No. D-V-18/Gen. 599

From:- Conservator of Forests
Chamba Forest Circle, Chamba

To: ✓ Nodal Officer -cum-APCCF (FCA)
O/o Pr. CCF, H.P, Shimla-1

Subject:- Diversion of 3.7463 hectares of forest land in favour of Chamba Hydro Ventures, Hotel Alps Resorts, PO and Tehsil Dalhousie, District Chamba HP for the construction of Ghatore Top SHEP (4.98M.W.) within the jurisdiction of Bharmour Forest Division Distt. Chamba HP (Online Proposal No. FP/HP/HYD/155802/2022)

DUMPING SITE-I (ROAD)

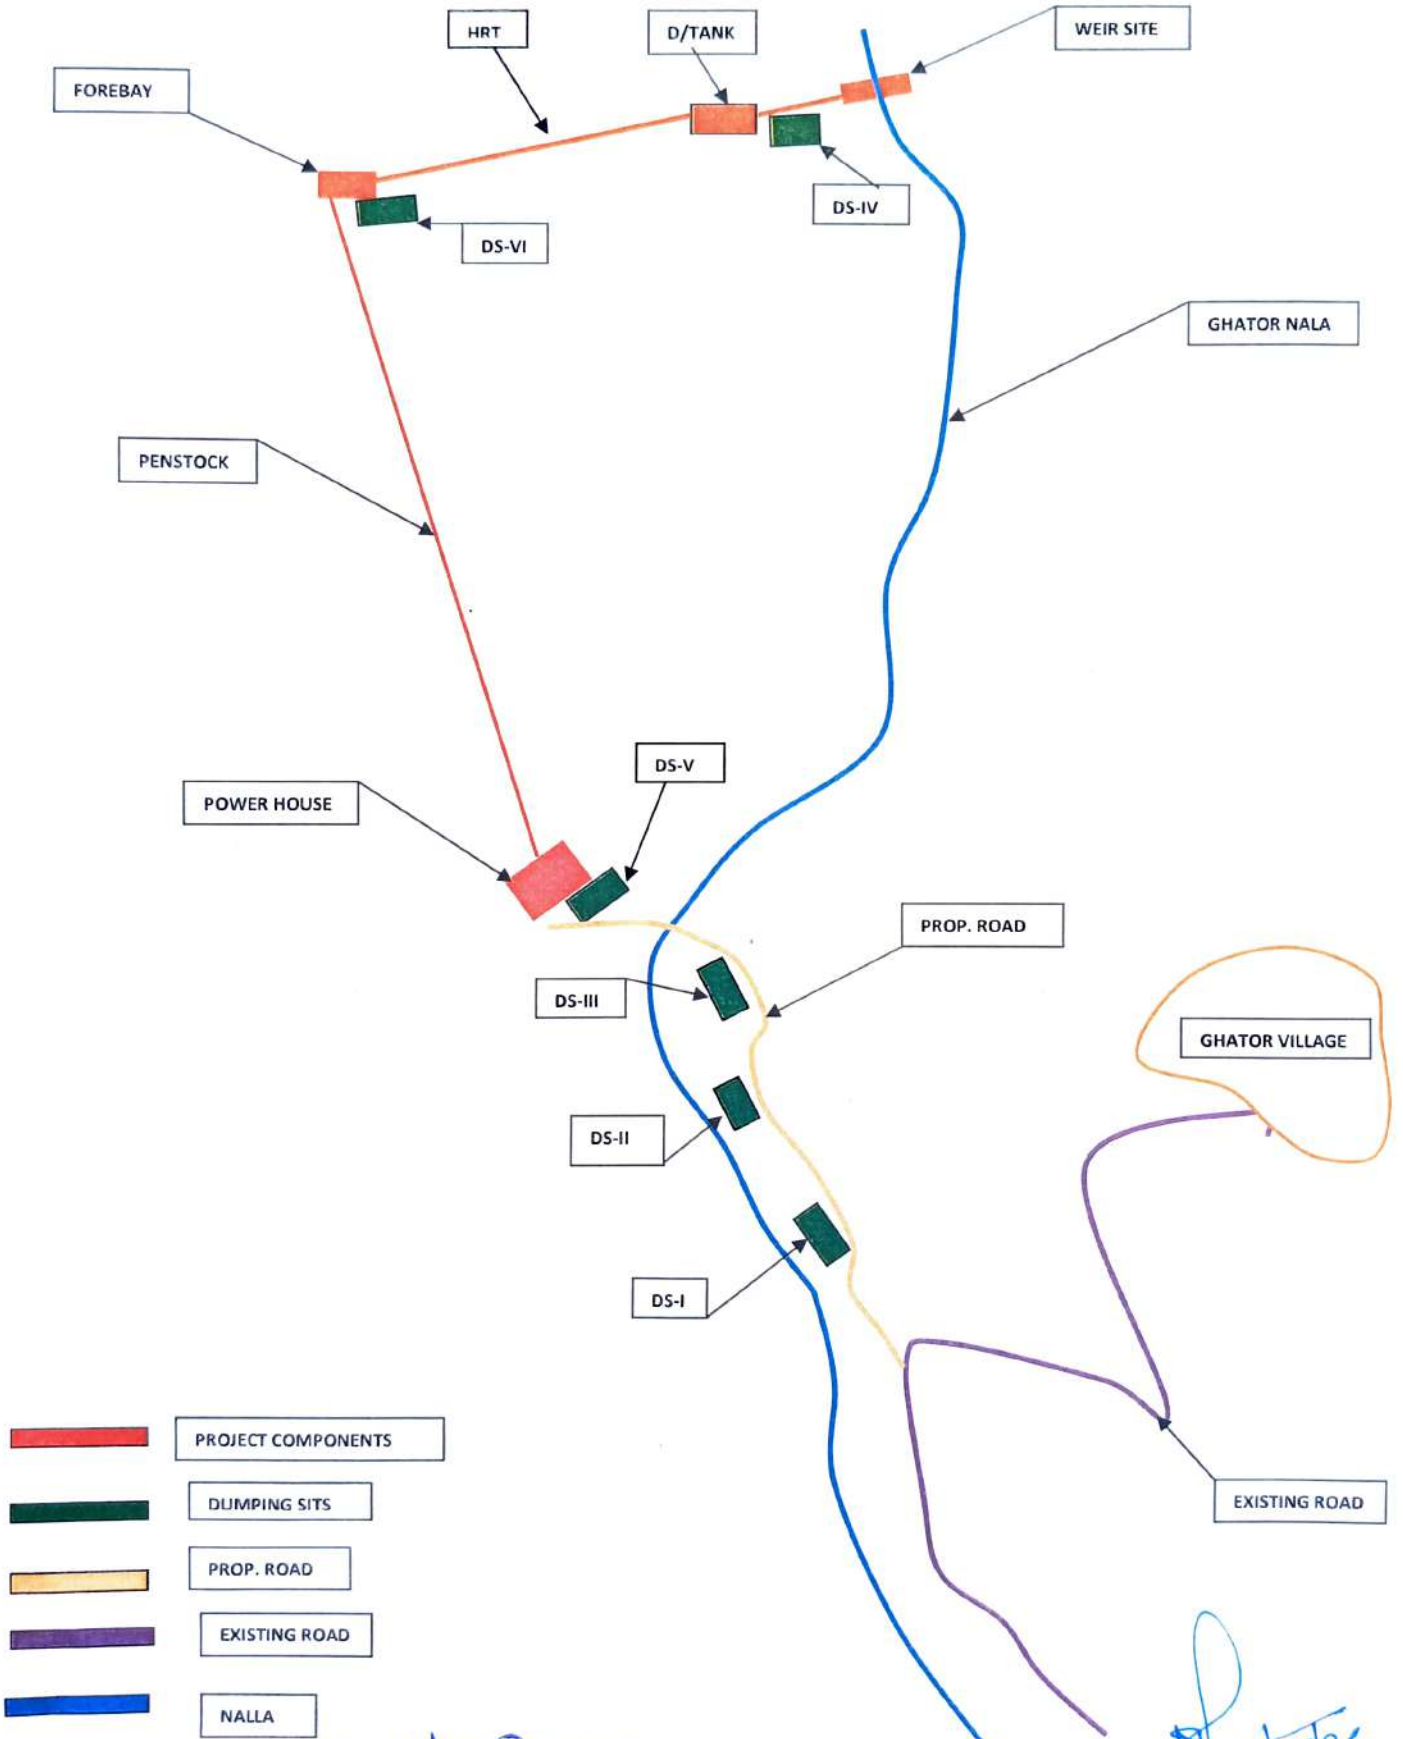
S. No	Observation	Reply
1.	The State Government is required to submit complete details of the trees standing within the proposed muck dumping sites along with the photographs of the dumping sites, authenticated by the concerned DFO. In addition, the State Government need to submit an undertaking stating that no trees will be felled within the proposed muck dumping sites.	DFO Bharmour has submitted that there are no trees standing within the proposed Dumping Sites (I to VI) of the Ghatore Top SHEP (4.98 MW), as verified by the field staff. The authenticated field verification report and geo-tagged photographs of all proposed dumping locations have been uploaded in PDF format. Furthermore, a formal undertaking certifying that "no trees shall be felled within the designated muck dumping sites" has been executed by the User Agency and uploaded against Additional Information in Part-I on the Parivesh Portal.

2.	The State Government is also required to clarify the approach proposed for accessing the dumping sites. Details of approach road to access the proposed dumping sites need to be submitted.	The Ghatore Top SHEP is a high-head scheme optimized to minimize surface footprint. Consequently, muck handling will primarily be executed manually. Out of the six proposed sites, four (4) dumping sites lie directly parallel to core project components (the approach road and Power House), requiring no independent access infrastructure. The remaining two (2) sites are adjacent to the Weir site, HRT, Desilting Tank, and Forebay, where construction and mucking will be handled manually via localized project pathways. A

comprehensive Access Plan detailing these configurations has been compiled and uploaded as supplementary data under Part-I.
3.	The State Government needs to submit a comprehensive report detailing with the bioengineering measures proposed to prevent the rolling of muck into the nallah, along with a clear statement of the financial outlay. The report shall also specifically include proper and scientific protection measures for safeguarding existing green standing trees, if any.	In reply to this observation user agency has submitted that the proposed dumping locations are completely devoid of existing standing trees or dense vegetation, robust protection measures are planned to secure the local ecosystem. To effectively prevent muck from rolling into the adjoining nallah during both construction and operational phases, a comprehensive Catchment/Muck Bioengineering Plan—complete with a detailed financial outlay—has been prepared and uploaded under Part-I on the portal.

This is to be certify that there are not any standing trees standing in the proposed Dumping sites for the execution of Ghator Top SHEP being executed by Chamba Hydro ventures . Hotel Alps resorts, Tehsil Dalhousie, Distt. Chamba HP.

EVACUATION PLAN OF GHATOR TOP SHEP 4.98 MW

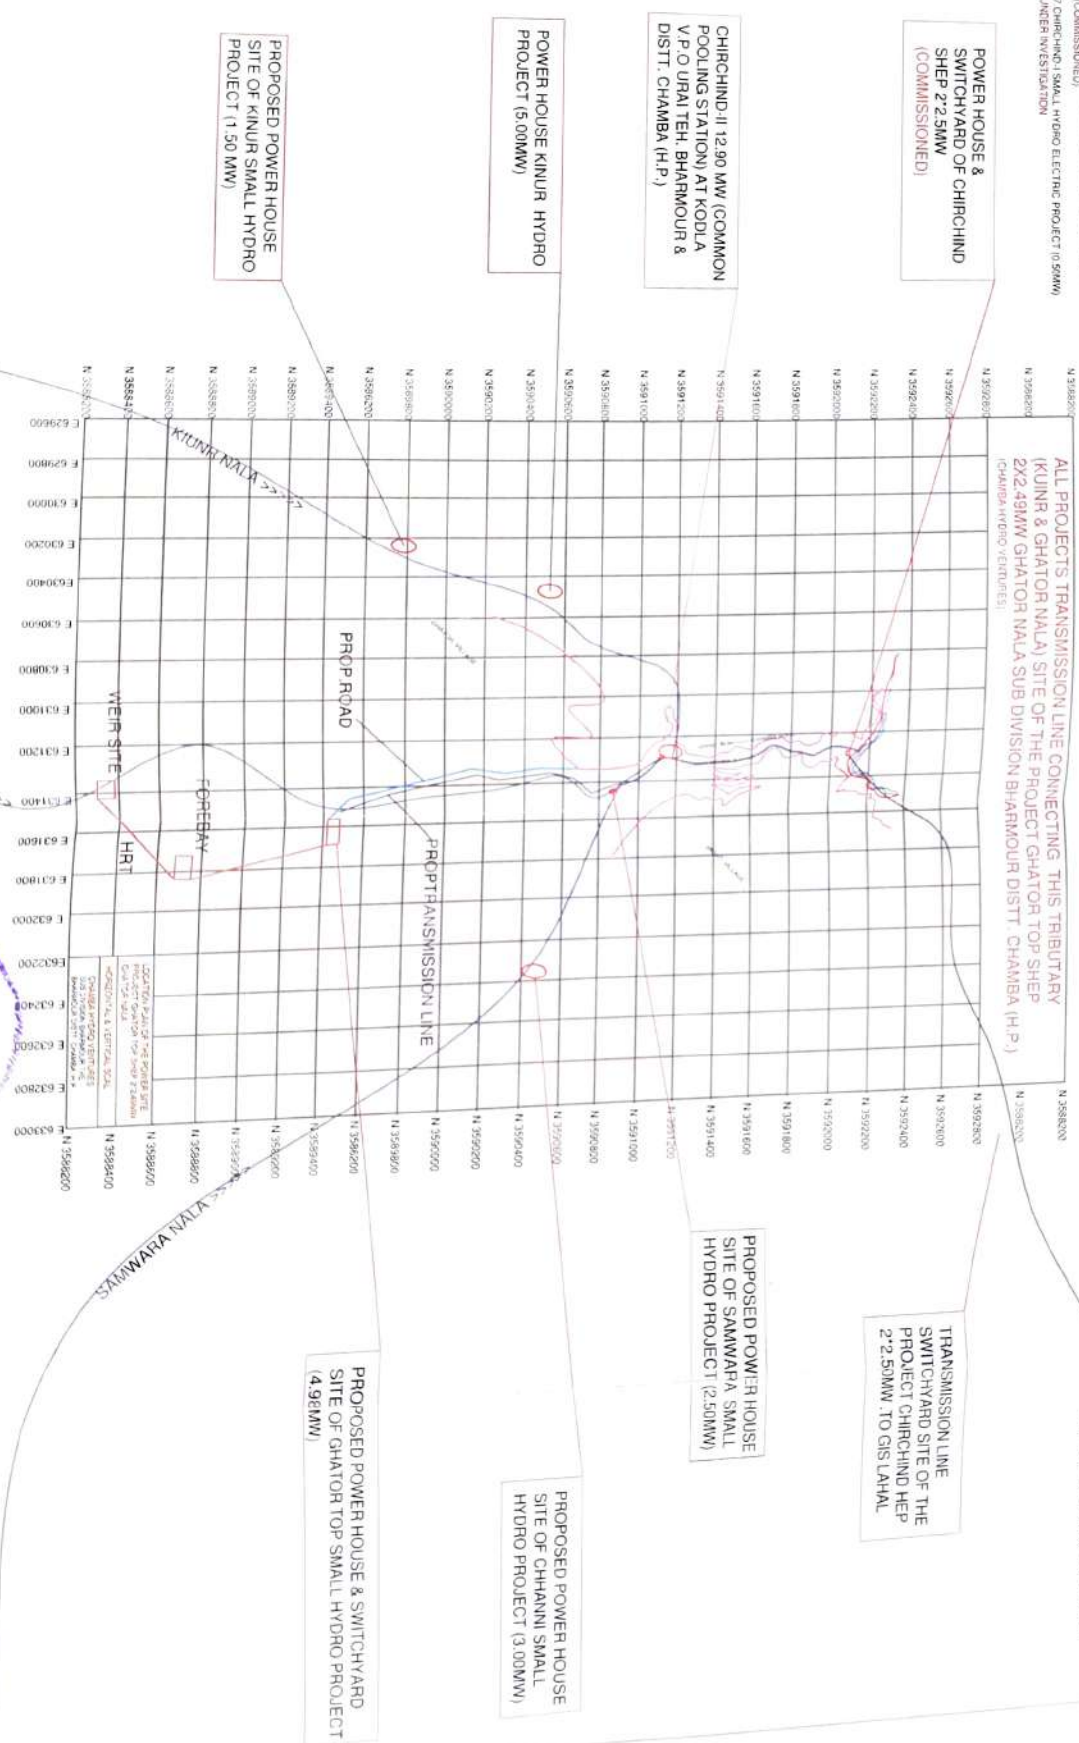
7.	State Govt. needs to submit the detailed Evacuation Plan of the instant proposal.	The detailed Power Evacuation Plan, along with its technical layout, has been successfully uploaded into the Additional Information

module of the online proposal.
8.	State Govt. needs to submit the revised DGPS map of the diversion area in legible format showing lat/long of the components.	A high-resolution, legible Differential GPS (DGPS) map, distinctly demarcating the latitudes, longitudes, and boundary pillars of all critical project components, has been uploaded under Part-I by the User Agency.
